> SKPR2020.15-Sketch Plan Review #1 Re:

> > Applicant Imperial Mills' Responses Staff Sketch Plan Review Letter dated

IMPERIAL MILLS - TECHNICAL DATA SHEET

BELMONT, NC

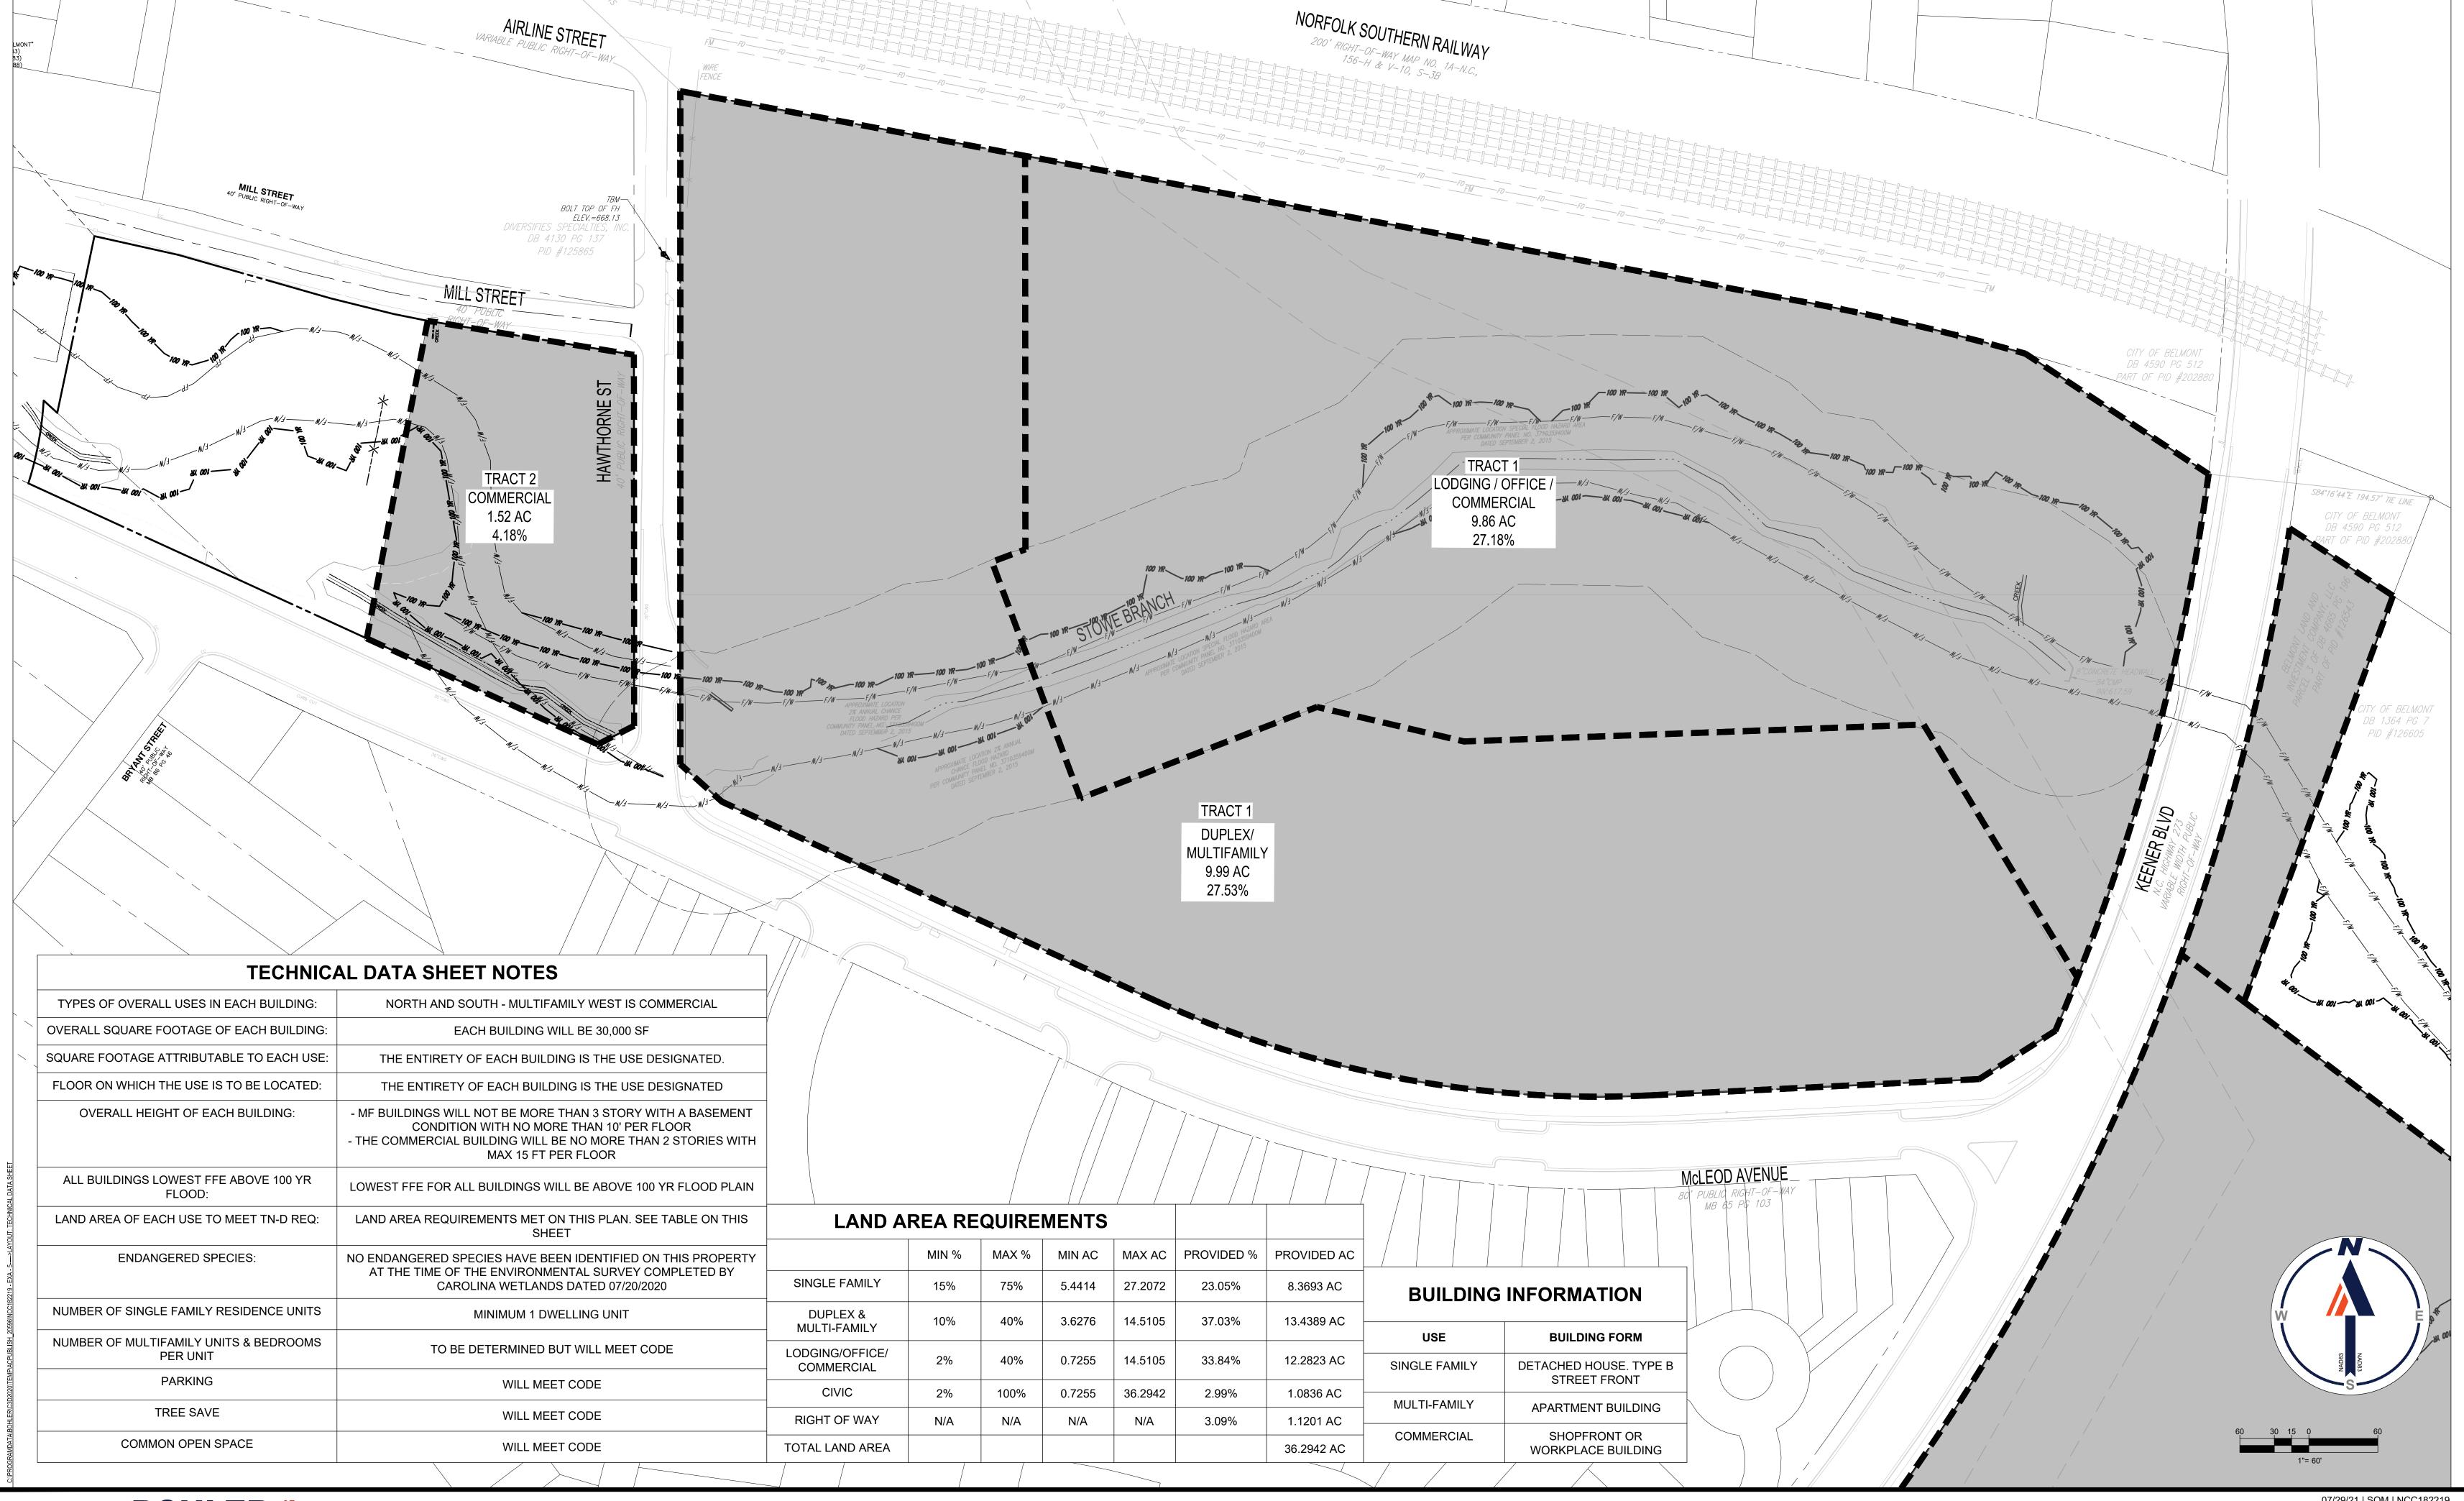
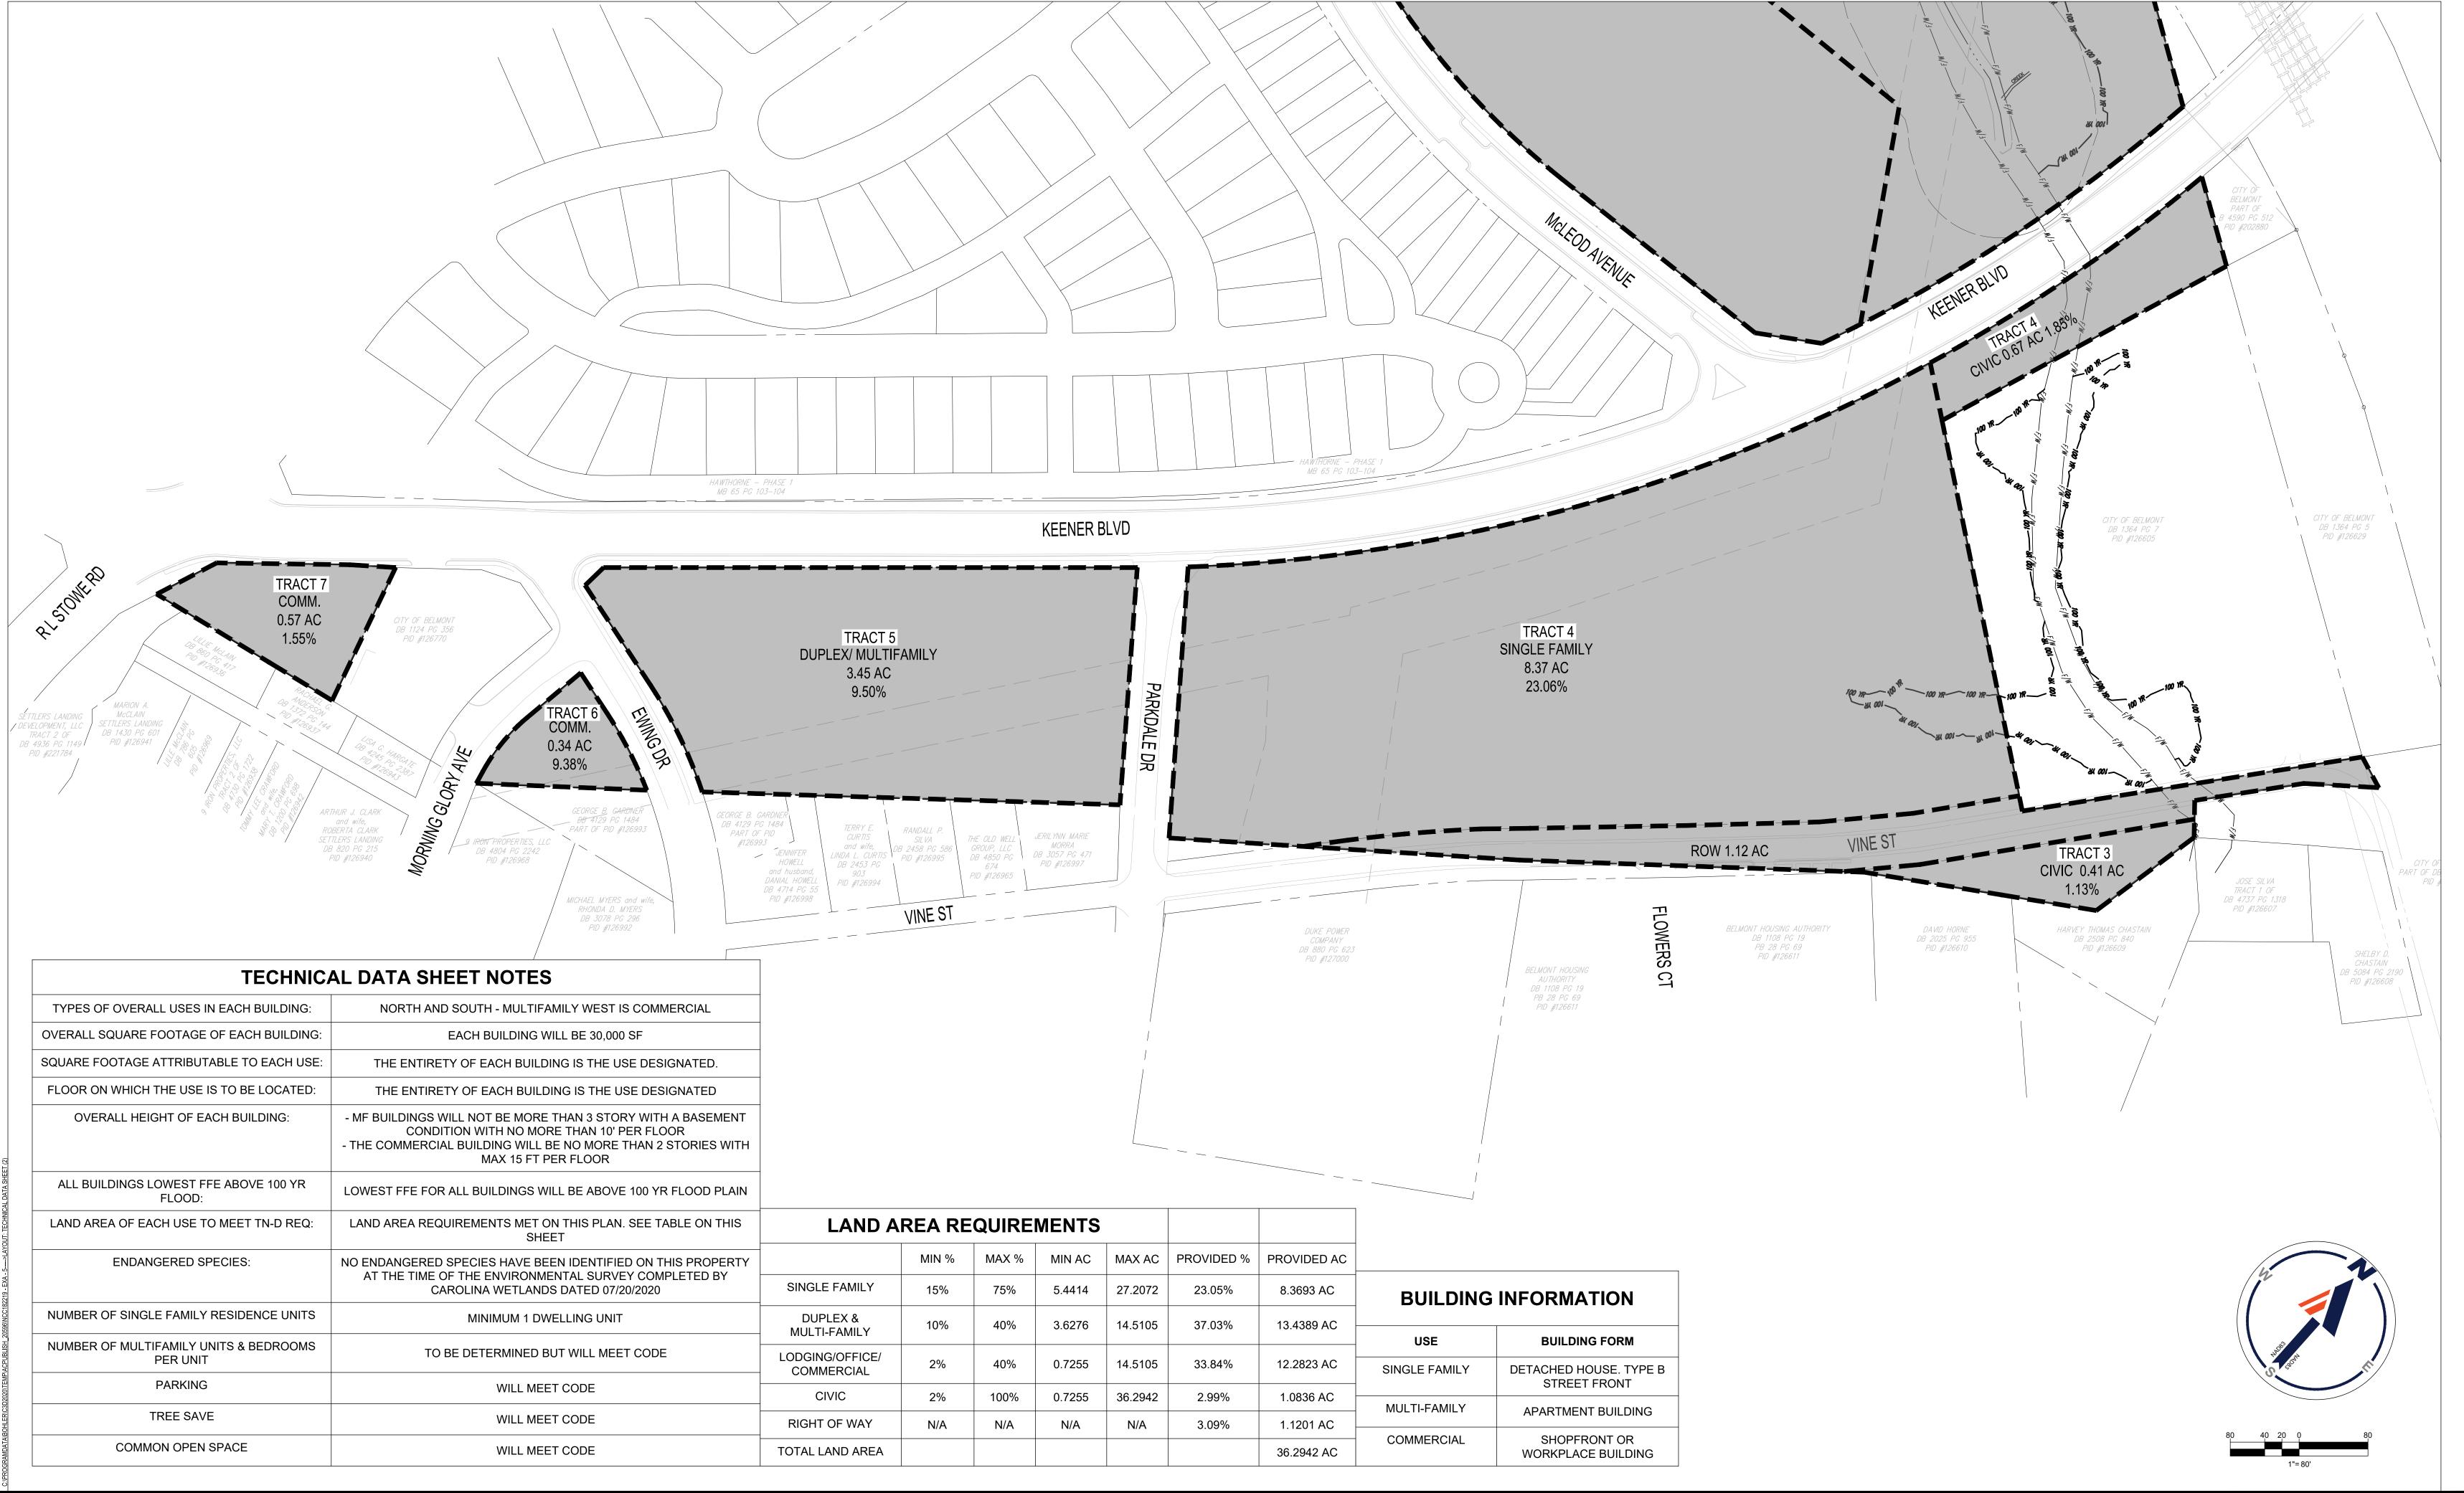
- a. Revised "By Right" Sketch Plan Sheets for "Tracts" 1, 2, 3, 4, 5 6 & 7 of the Parcel;
- b. Revised Consolidated Sketch Plan
- c. Digital GIS Aerial of Entire Parcel
- d. Environmental Survey for additional acreage
- e. Revised Slope Analysis
- f. Revised Tree Inventory Maps (for additional acreage)
- g. Revised Tree Inventory and Survey (for additional acreage)
- h. Revised Technical Data Sheet
- i. Revised Proximity Map with Road Names
- j. Revised Illustrative Elevations Exhibit
- 2. **Subdivision of Lots:** Based on the proposed lot subdivisions indicated on the Technical Data Sheet, the development of this project and proposed subdivisions of land would result in five parcels-- four within the proposed development area, and one containing the portion of the site not proposed for development. This would classify this project as a Major Development Plan.

<u>Response/Action</u>: Please see revised Technical Data Sheet. Our expectation is that we will be reviewed under the criteria for a Minor Development Plan.
